Memo

To:	Jerry Graham, Doug Fielding, Calvin Goldschmidt, Greg Blaylock	Date:	August 24, 2011
Company:	JDS	From:	Iozsef Miskolczi
Copy to:	Maritz Rykaart, SRK Lowell Wade, SRK	Project #:	1CH008.033.0350
Subject:	Site Directive for Sump Detail of Primary Vent Raise

Figure 1 shows the Typical Detail of the sump that should be read in conjunction with the Fuel Tank Containment Liner Plan shown on drawing DN-PVR-04[HB+D-CIV-CIV-OND-0136] associated with the Primary Vent Raise Pad drawings package.

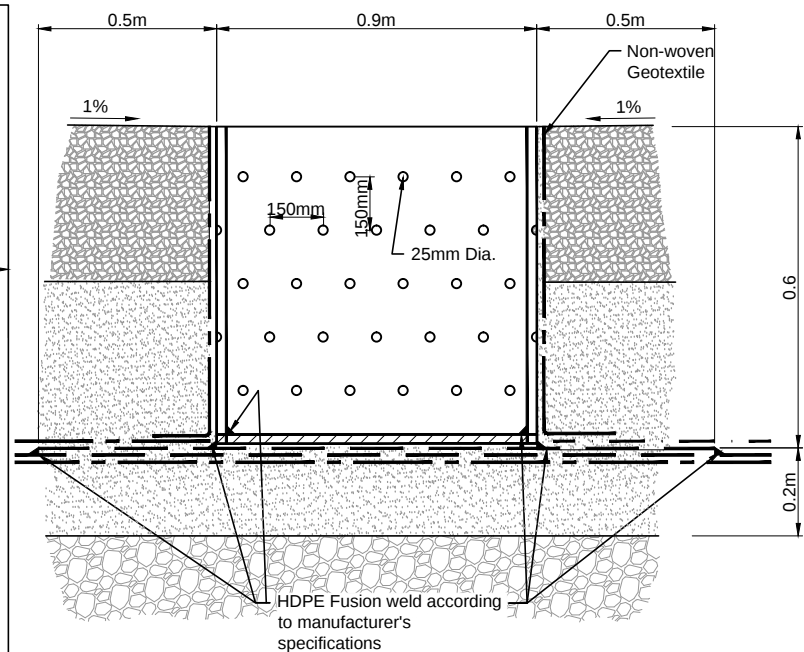
The IFC drawing package detailing the Primary Vent Raise construction does not contain details for the collection sump within the Fuel Containment Area. Also, the floor of the containment area shown on drawing DN-PVR-04[HB+D-CIV-CIV-OND-0136] is flat.

To achieve the required 1% minimum drainage grade within the Fuel Containment Area, the location of the sump will be staked out as shown in the Fuel Tank Containment Berm Stake Out Table, except the elevation will be set at 48.25 masl. The crush cover within the footprint of the sump will be cut to match this elevation, while the remaining floor surface of the Containment Area will be regraded from the perimeter toward the sump to match the staked-out elevations. The elevation of the floor perimeter is to remain as is.
